3a. CU 17-01 / SP 17-16 / VR 17-01: North Clackamas Christian School

Modular Building

Staff Report

File Number: PC 17-057

Proposed Exterior Elevations

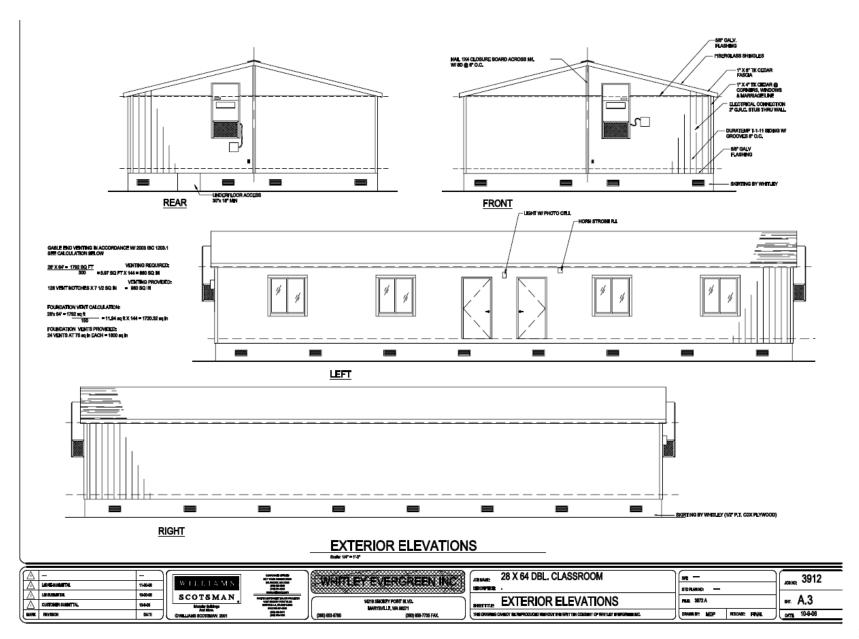
Finding: complies with condition. The applicant's narrative and submitted building plans are in conflict. The narrative states that the exterior materials will consist of horizontal composite siding and fiberglass roofing shingles, but the applicant's building exterior plans indicate the use of T-111 siding, a prohibited building material. The applicant shall not use T111 siding, but shall indicate the use if composite or wood siding on construction plans prior to issuance of a building permit. The site is not within a historic district and is not a designated historic structure. The applicant proposes to keep the chain link fencing that surrounds the site, in its current condition. Building and painted surfaces will be maintained for cleanliness and to prevent paint deterioration. **Staff has determined that it is possible, likely and reasonable that the applicant can meet this standard through the conditions of approval.**

- 3. The applicant shall not use T111 siding, but shall indicate the use of composite or wood siding on all elevations and indicate this materials on construction plans. (P)
- 4. The applicant shall provide a revised landscaping plan with the statement that no mulch, bark chips, or similar materials shall be allowed at the time of landscape installation except under the canopy of shrubs and within two feet of the base of trees. (P)
- 5. The applicant shall provide a revised landscaping plan indicating that all on-site pedestrian walkways shall be hard surfaced, well-drained and at least five feet wide.
